[Docket No. FAA–2024–1896; Project Identifier MCAI–2023–00978–T; Amendment 39–22966; AD 2025–04–08]

Airworthiness Directives; MHI RJ Aviation ULC (Type Certificate Previously Held by Bombardier Inc.) Airplanes

ACTION: Final rule.

Figure 1 to Paragraph (g)(1)—Fundamental Effective Isotropic PSD at Outside Interface of Airplane Antenna

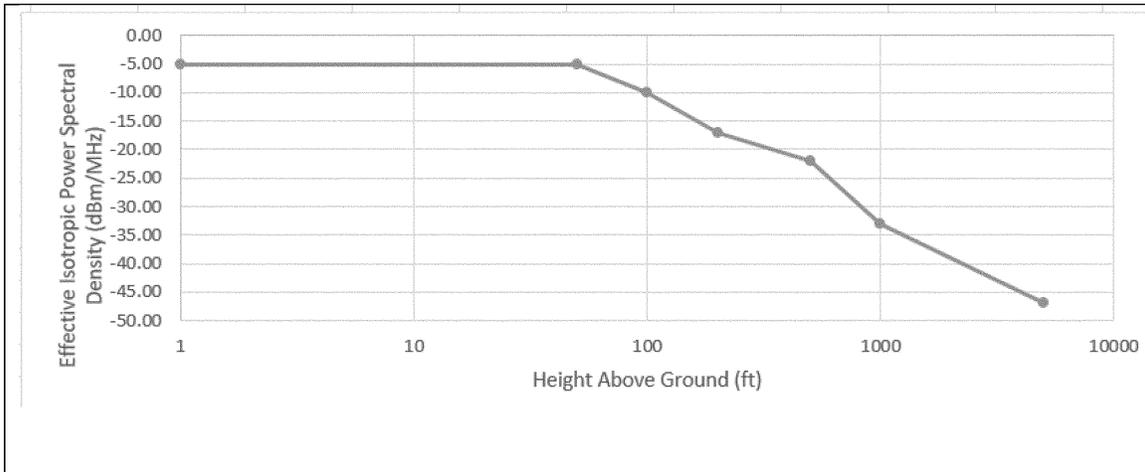
(1) Tolerance to radio altimeter interference, for the fundamental emissions (3.7–3.98 GHz), at or above the power

spectral density (PSD) curve threshold specified in figure 1 to paragraph (g)(1) of this AD.

Figure 2 to Paragraph (g)(2)—Spurious Effective Isotropic PSD at Outside Interface of Airplane Antenna

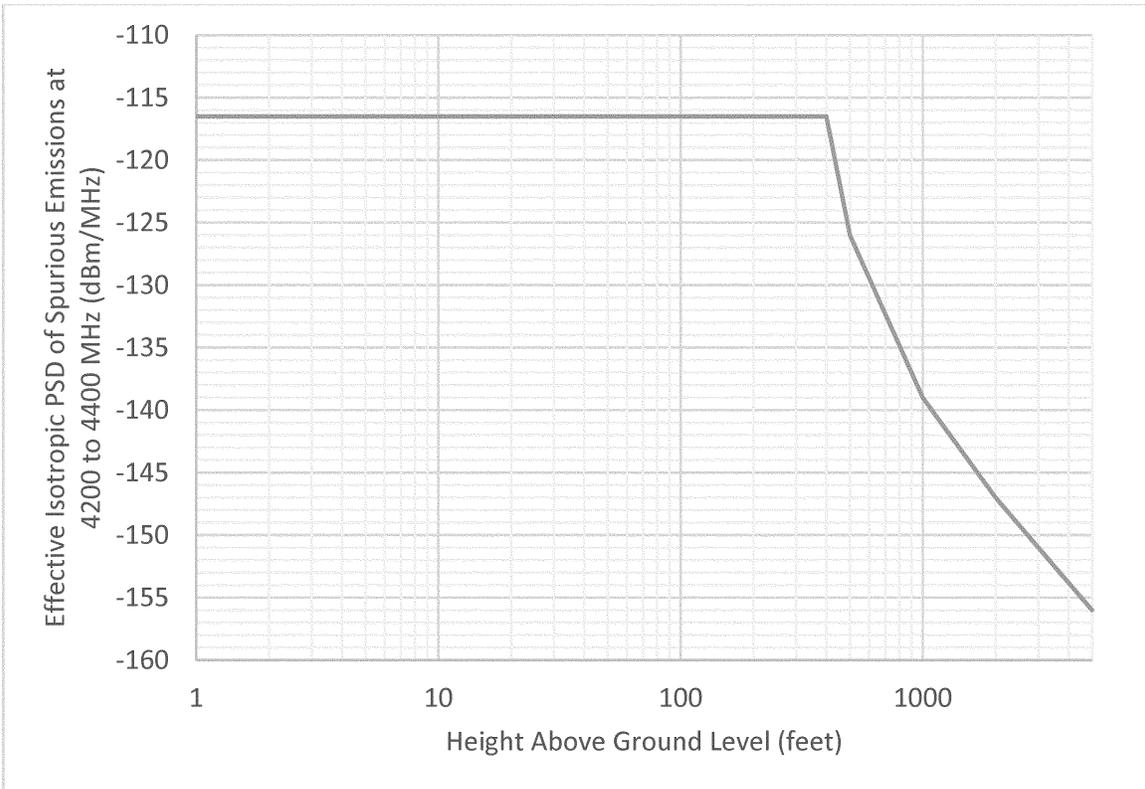
(2) Tolerance to radio altimeter interference, for the spurious emissions (4.2–4.4 GHz), at or above the PSD curve threshold

specified in figure 2 to paragraph (g)(2) of this AD.
